Service Bulletin

13-082

Warranty Extension: MIL Comes On With DTCs P0301 thru P0304

Supersedes 13-082, dated January 31, 2018, to revise the information highlighted in yellow.

54K PISTON

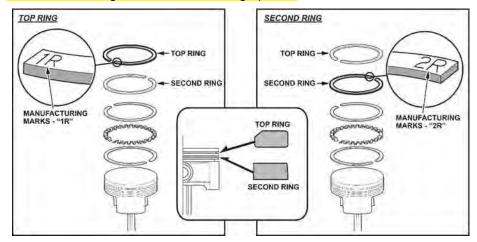
An image was add to REPAIR PROCEDURE B – PISTON CLEANING AND RING REPLACEMENT, Piston Cleaning and Ring Replacement Procedure.

NOTE: Below are some examples of before and after pictures. Depending on mileage and running conditions, the pistons will achieve different levels of cleanliness.
